Bucks Creek 1101- PM# 35217268 Overview Map

Subject: O8W-PM 35217268, 35224712, 35224713 - Bucks Creek 1101 Phase 1,2&3 - Pre-Engineering Meeting

PM 35217268 (Phase 1)

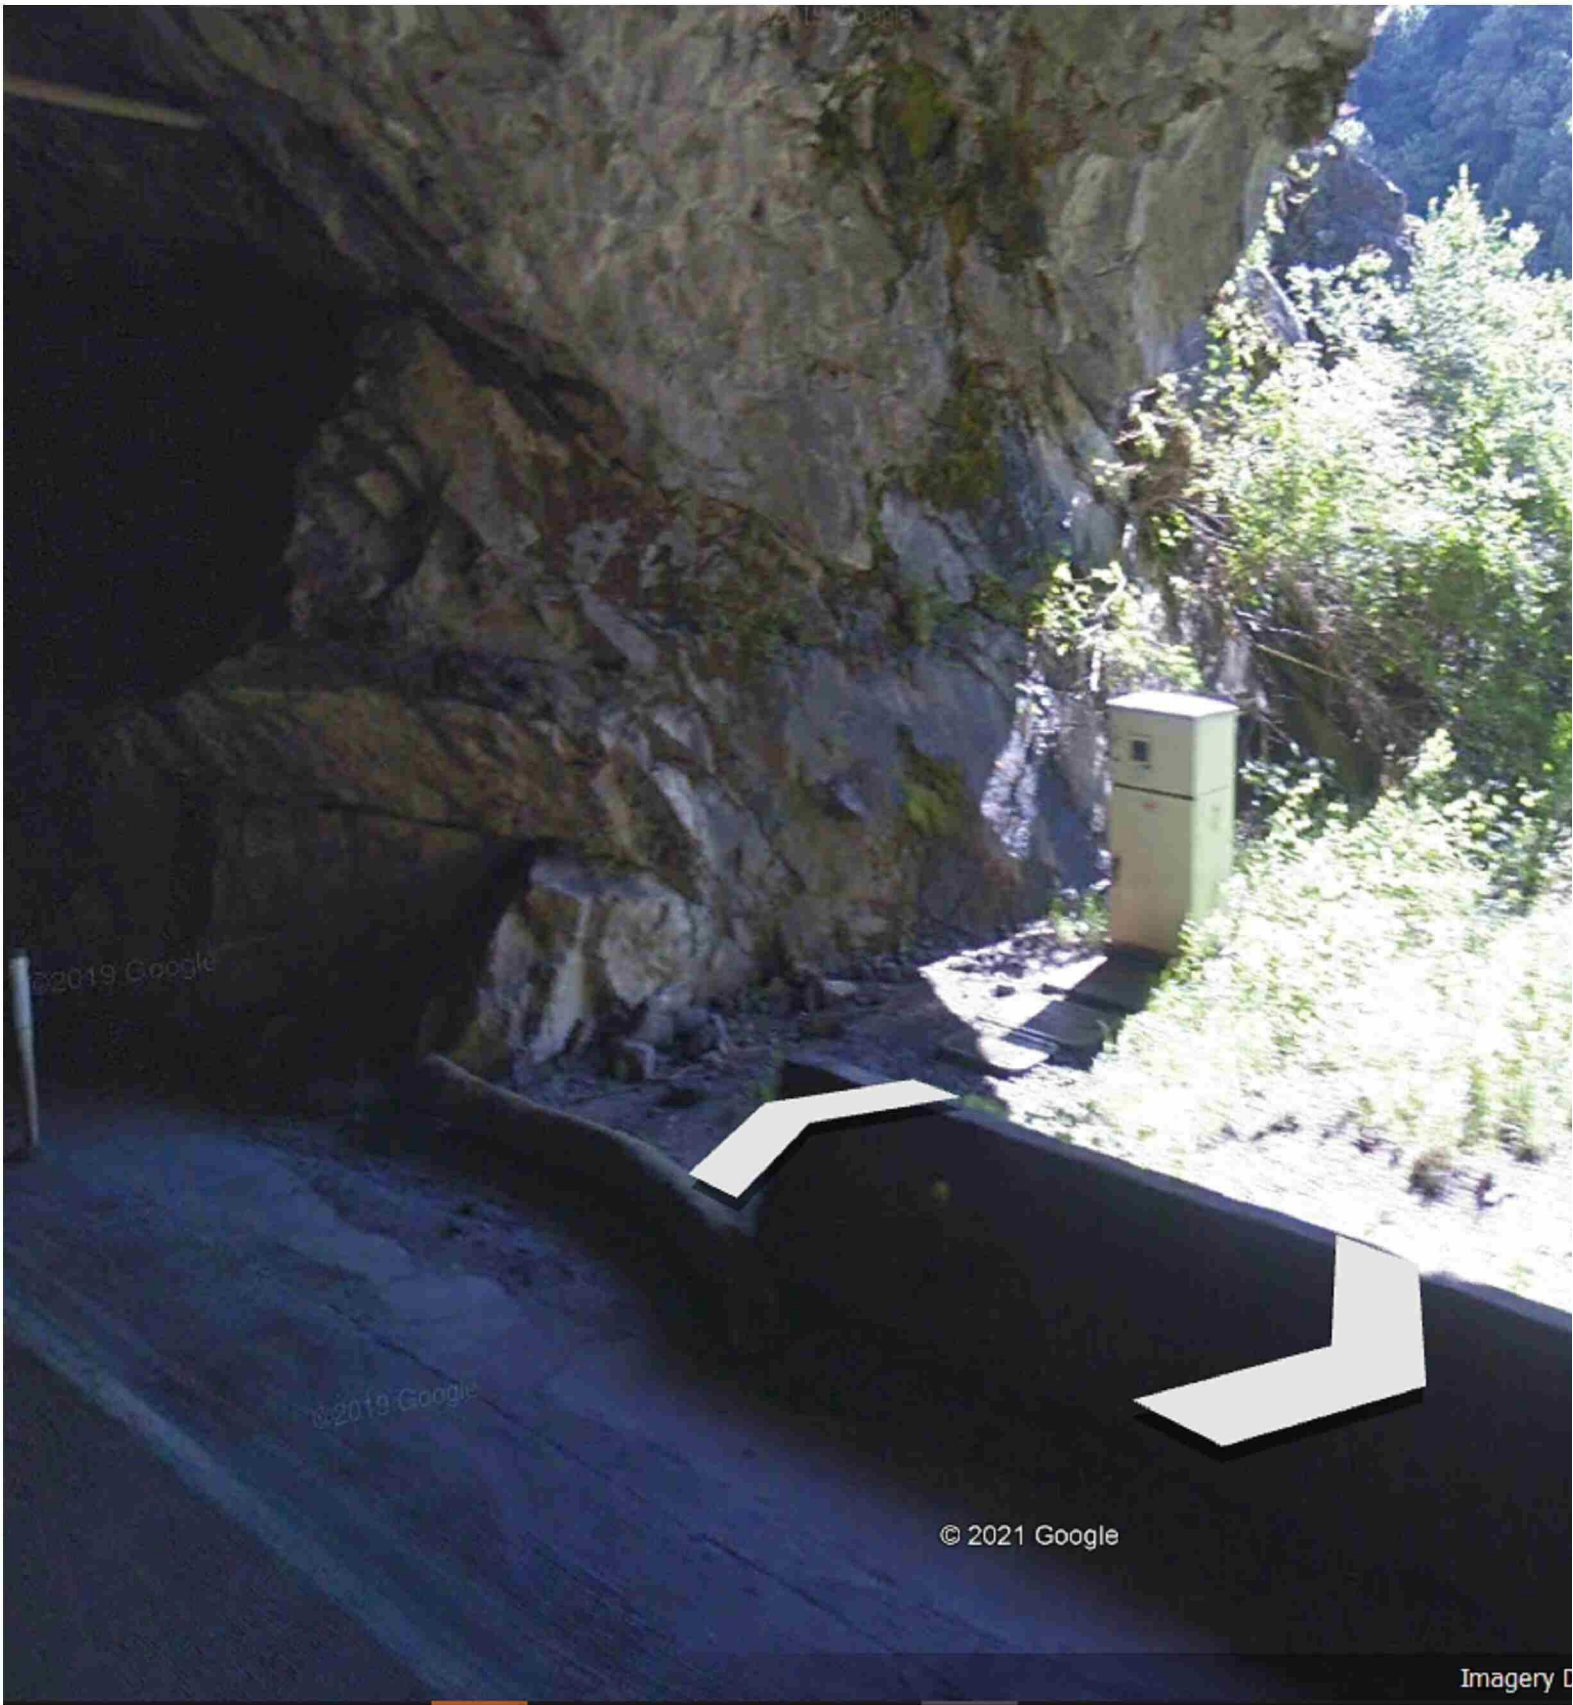
Attached are the 'base-map' limits in a kmz. file. As you will see, we need our base-map to go about ~100' into the tunnel at the south end (see pedestal in picture below....please begin about ~50 beyond this point which is about ~100' beyond the Cresta Dam).

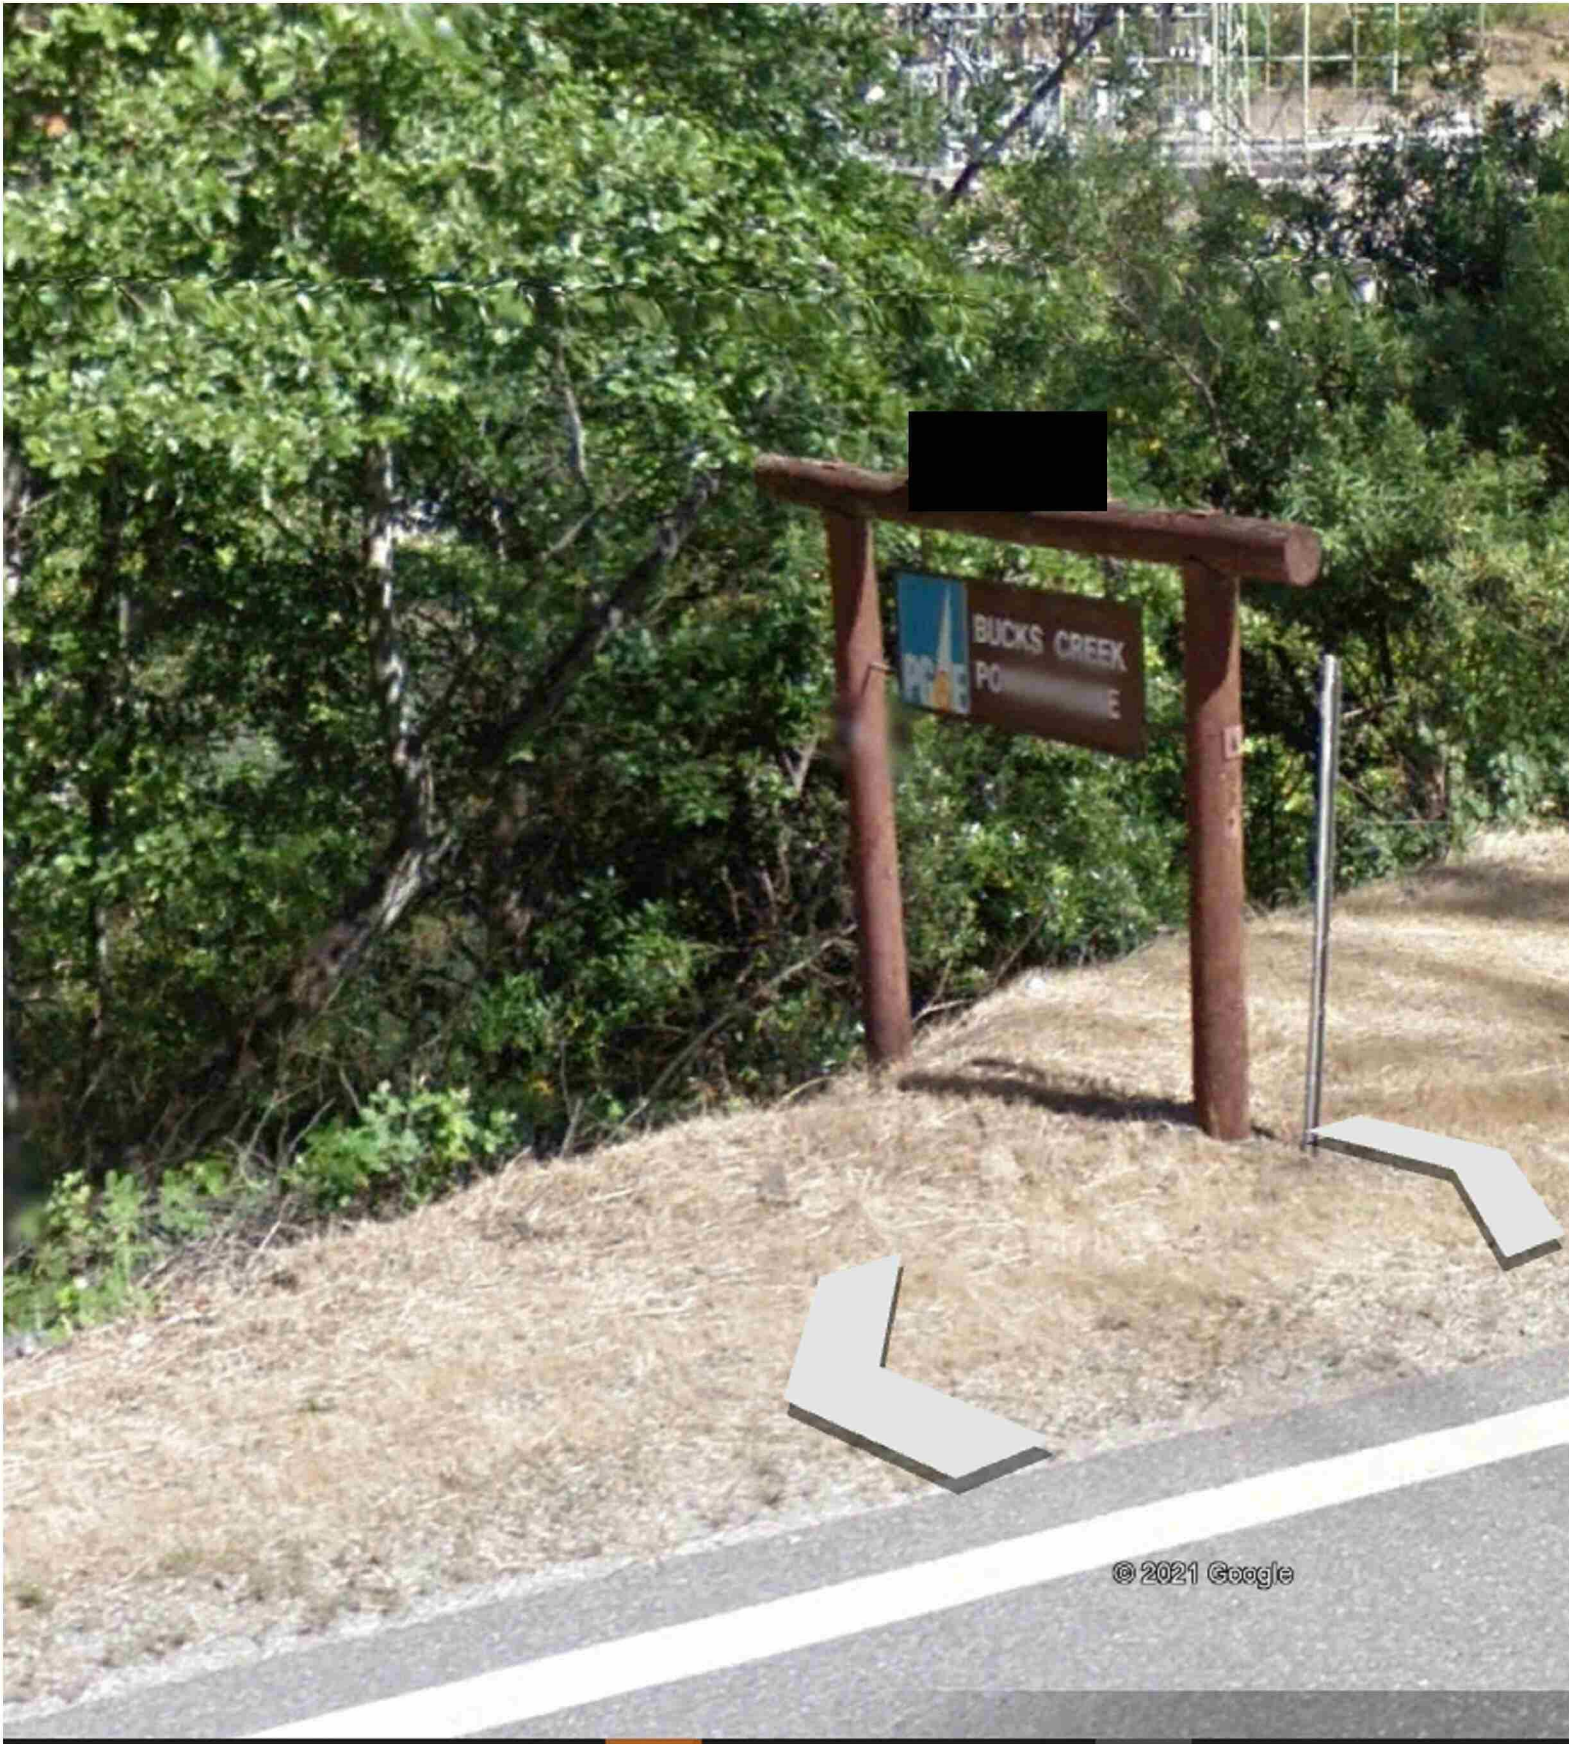
We want to end the base-map at the sign location below which is roughly at MM (Mile Marker) 5.10.

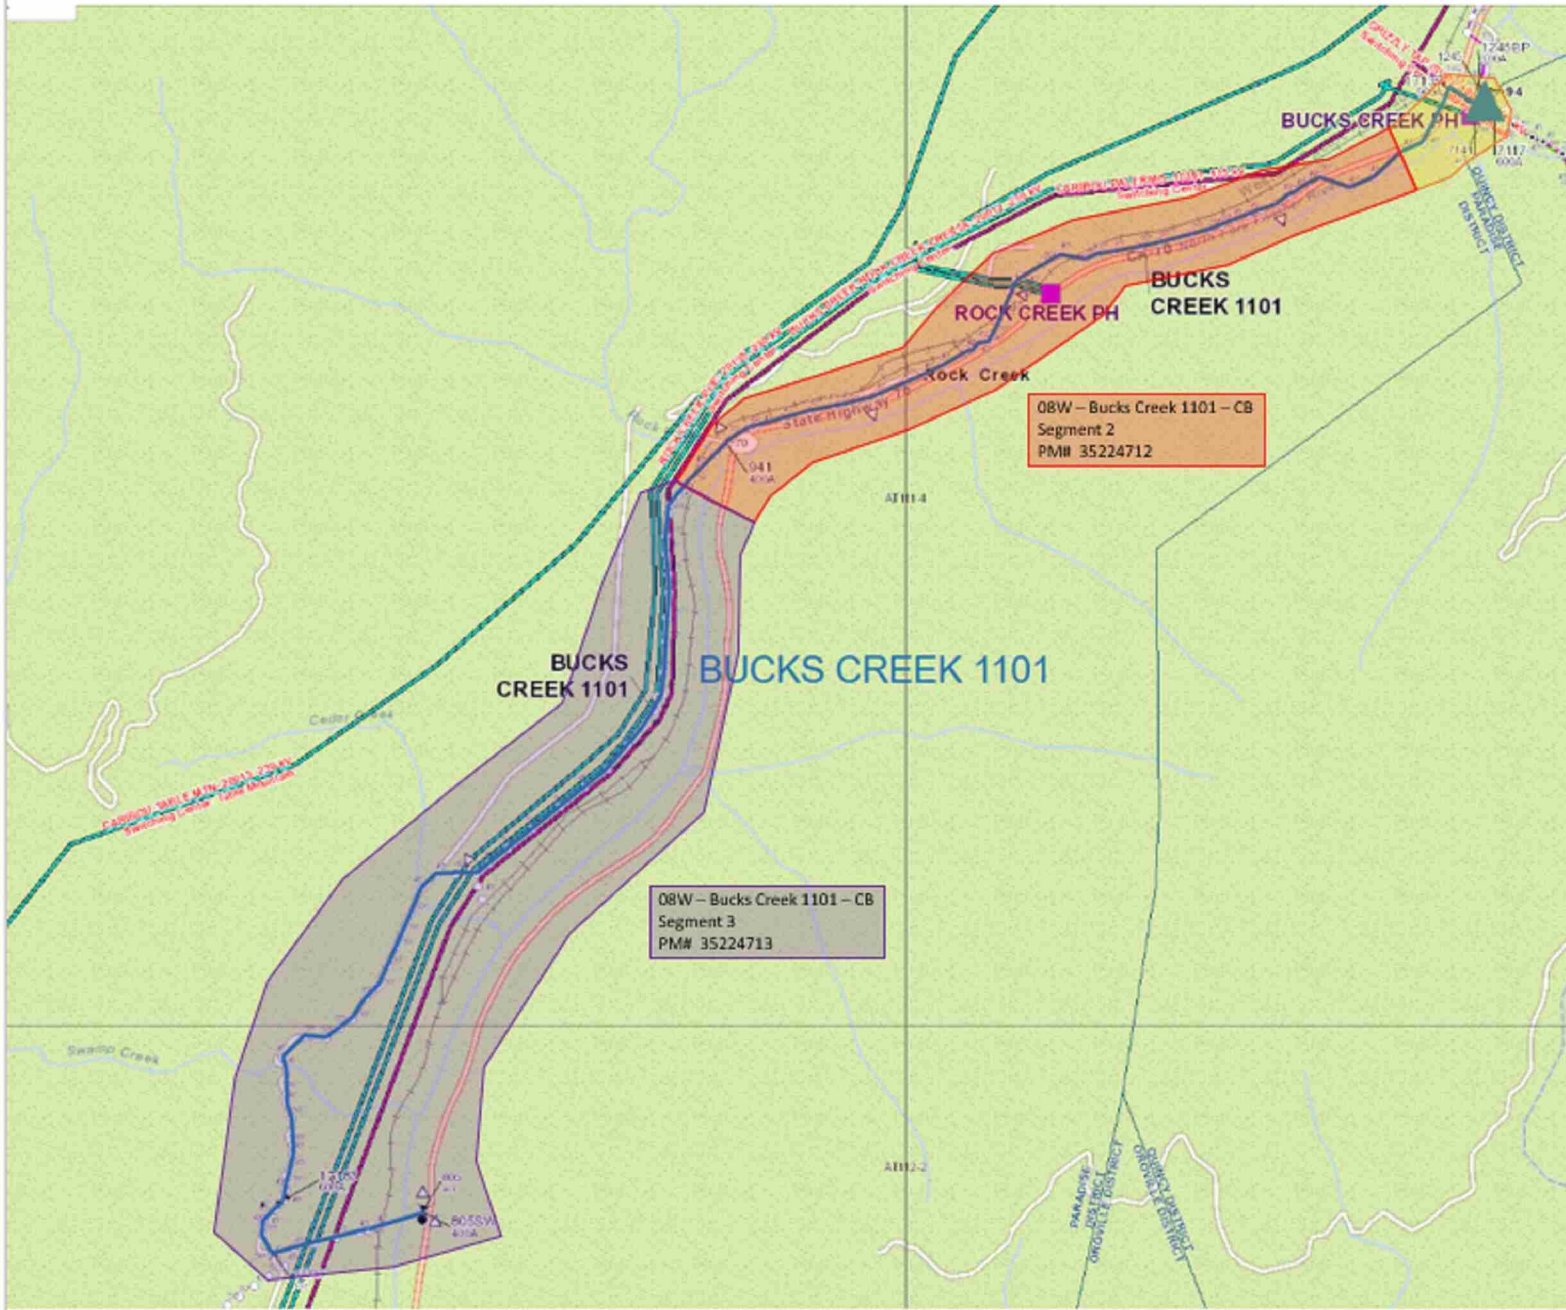
For Bucks Creek there is quite a bit of work surrounding Hwy 70 and we will need a Land Department Base Maps prepared for all 3 Orders. This will delay the EOD dates until these can be developed and provided to the Vendor... We will also need answers to the questions outlined by [REDACTED] below...
